ADDENDUM NO. 2

FEBRUARY 28, 2024

Staunton City Public Schools, VA
Shelburne Middle School Additions and Renovations
CRA Project No. 3636

HOLLOW METAL FRAM
DETAILS

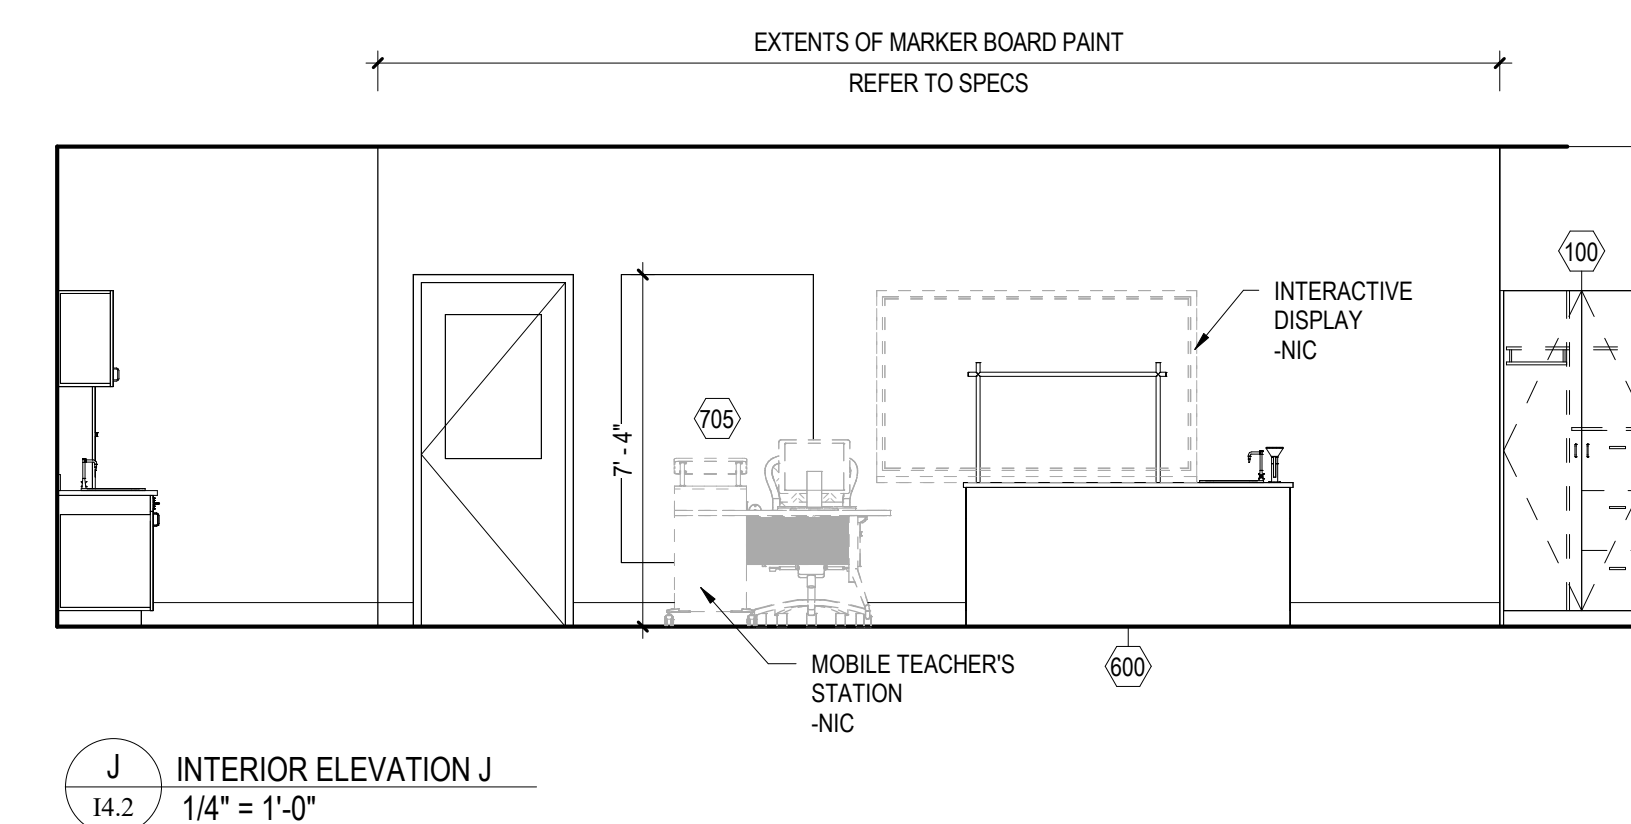
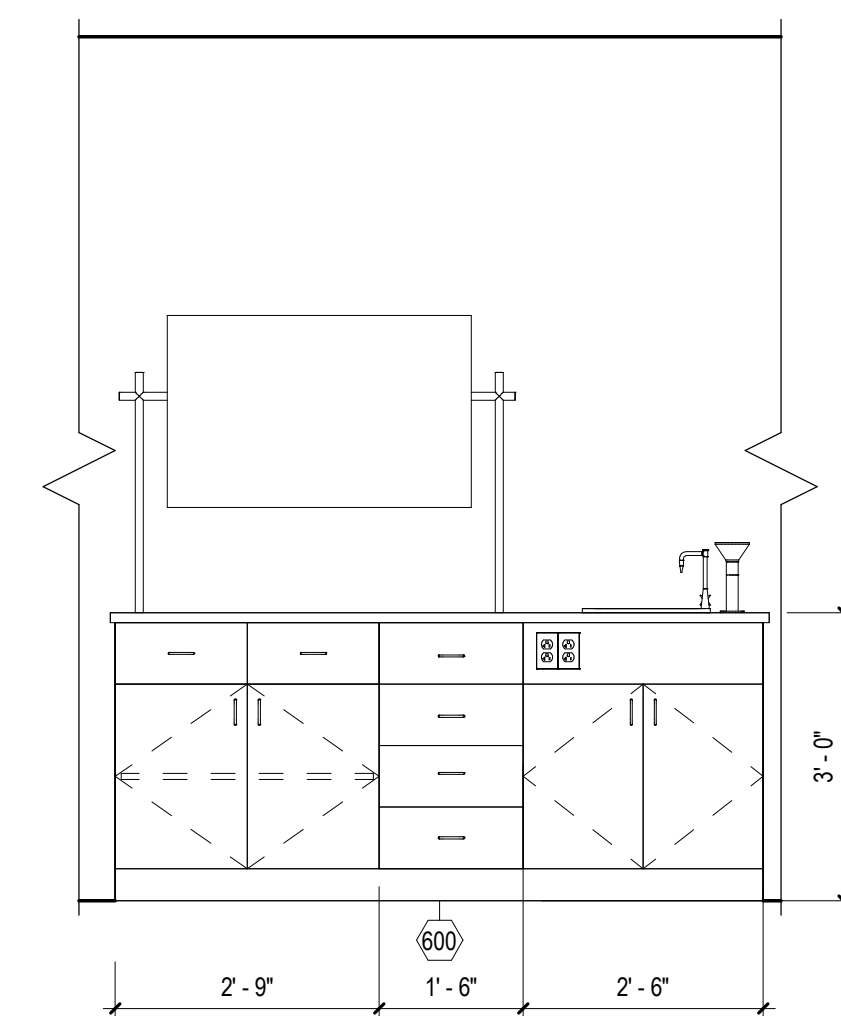
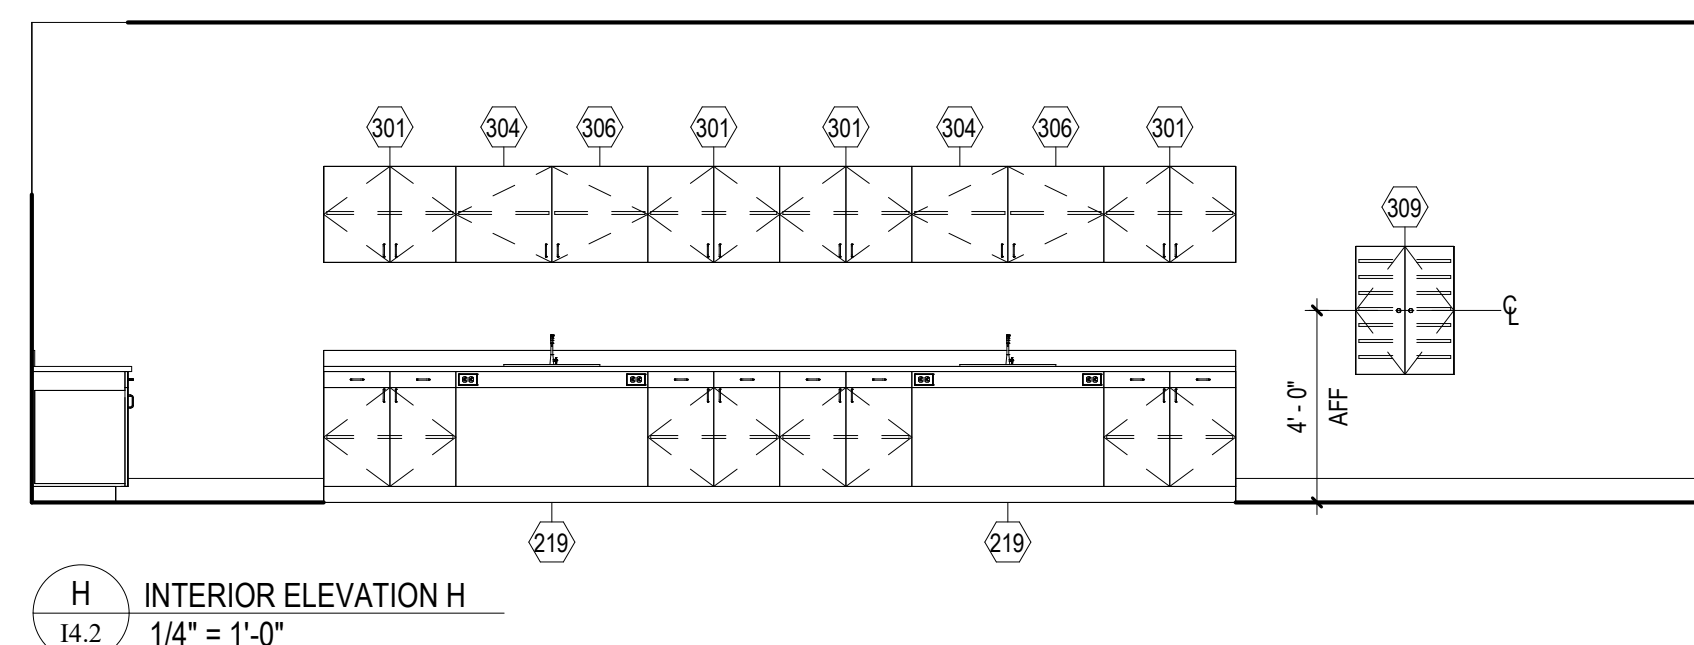
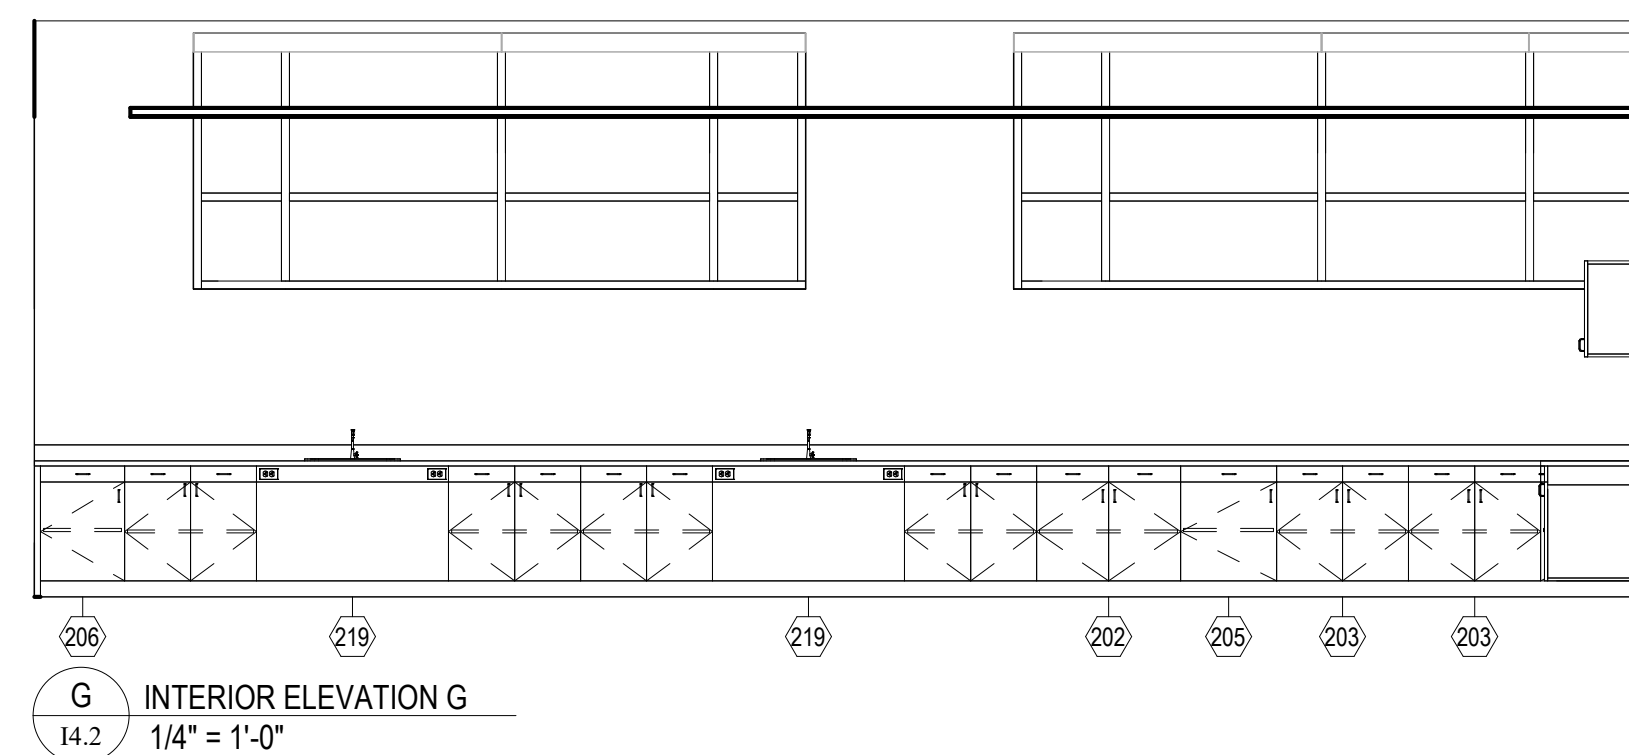
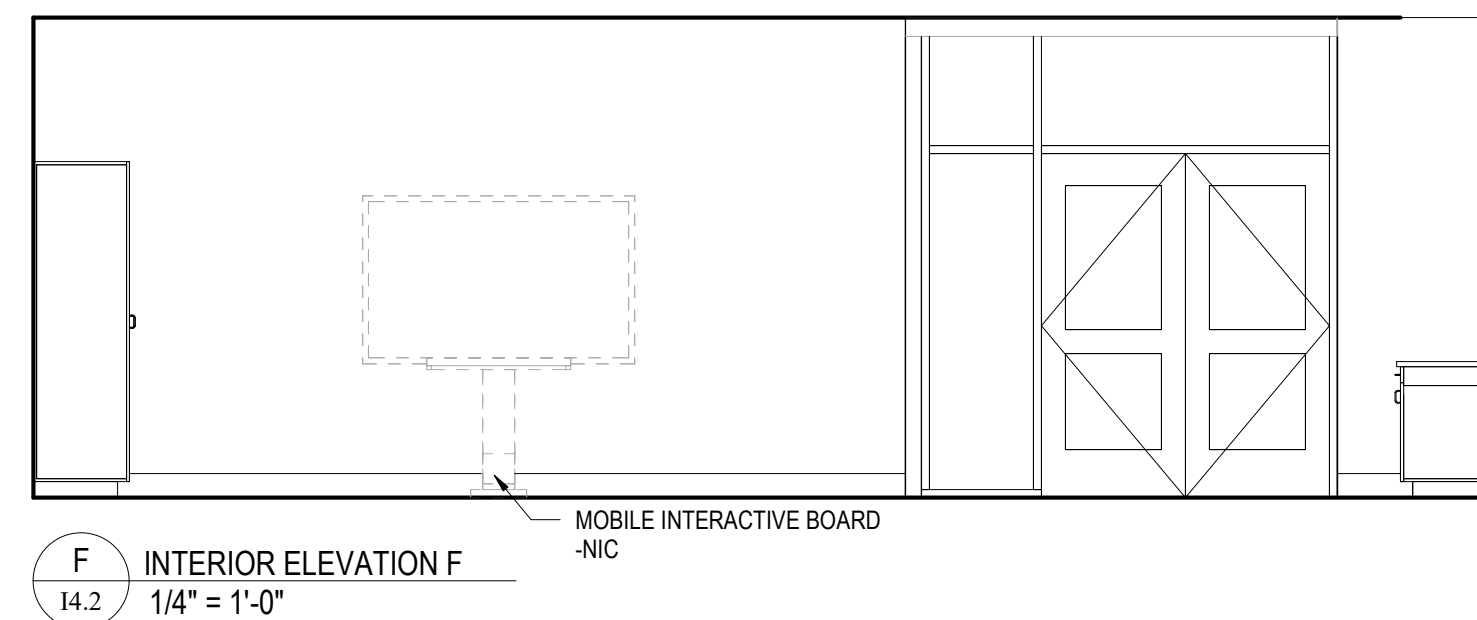
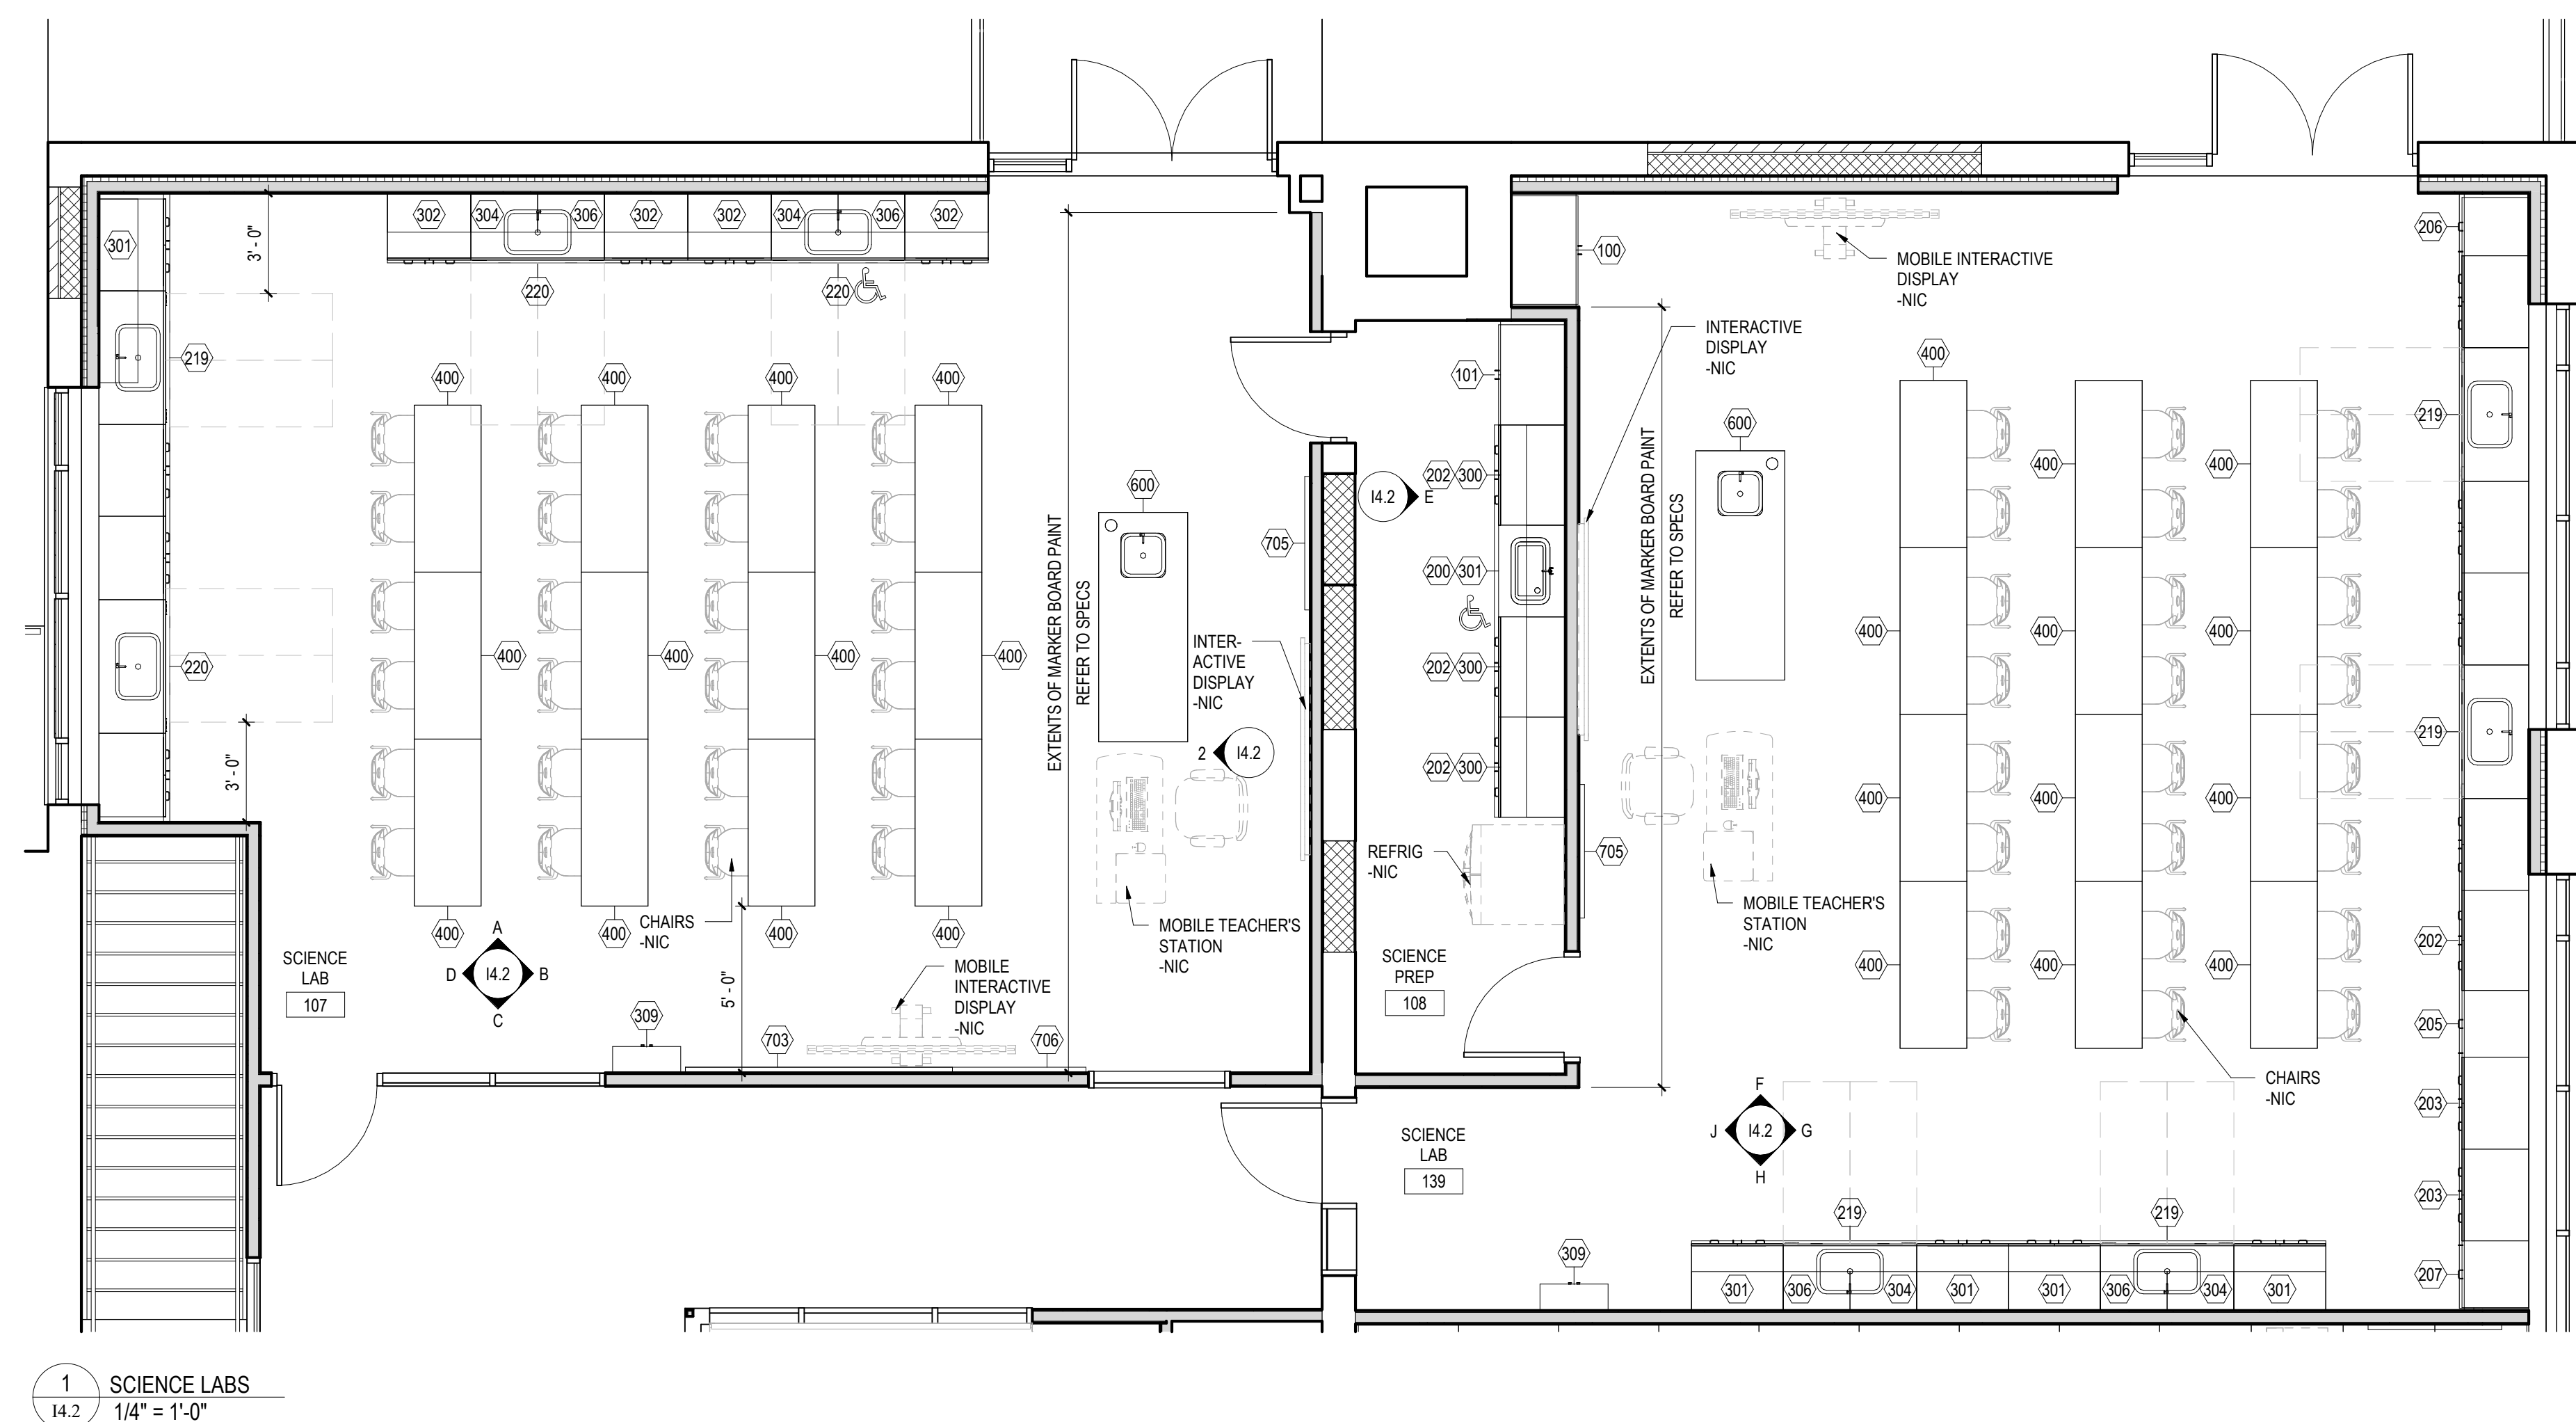
1. **DELETE** this sheet in its entirety and **REPLACE** with the attached sheet.
 - a. **ADD** Coiling Counter Door Details.

LARGE SCALE LAYOUTS - SCIENCE LABS	
PLOT SCALE:	As indicated
FILENAME:	
DATE:	01/24/2023

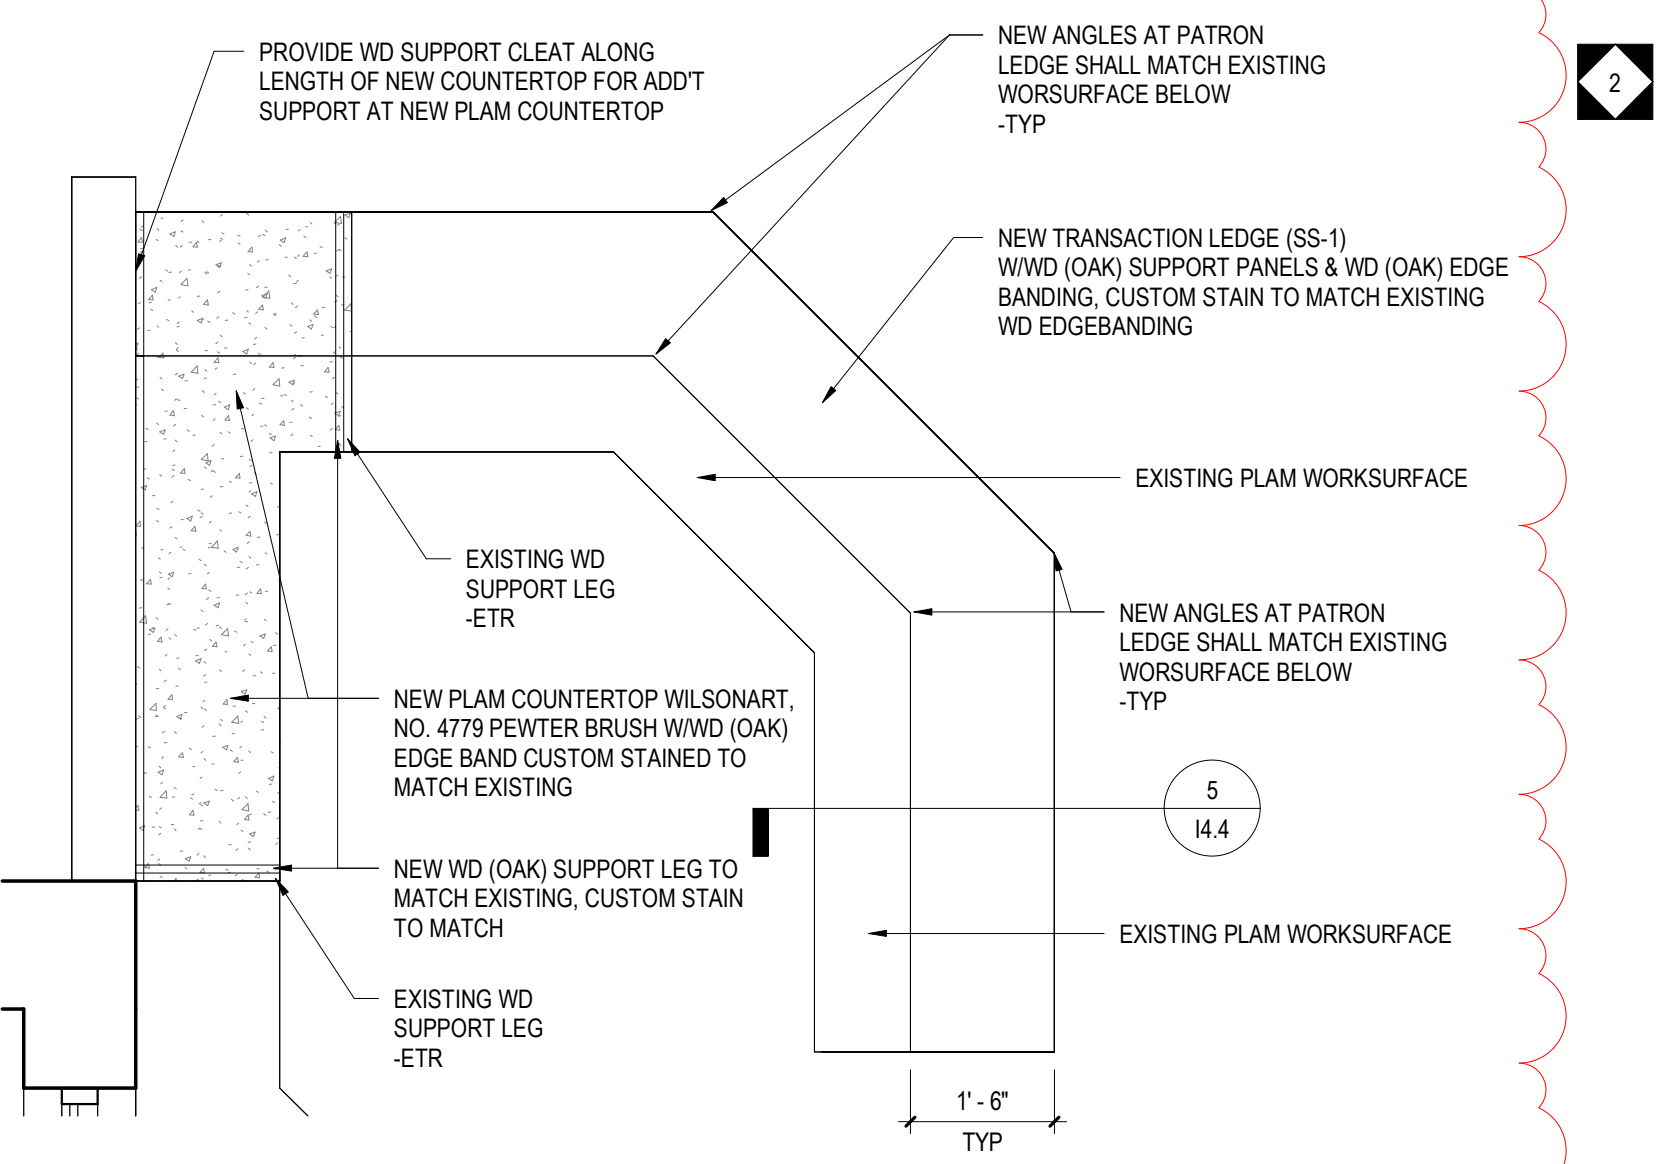
1. **DELETE** this sheet in its entirety and **REPLACE with the attached sheet.**
 - a. **REVISE** item no. 400, description, model & dimensions per the attached sheet.
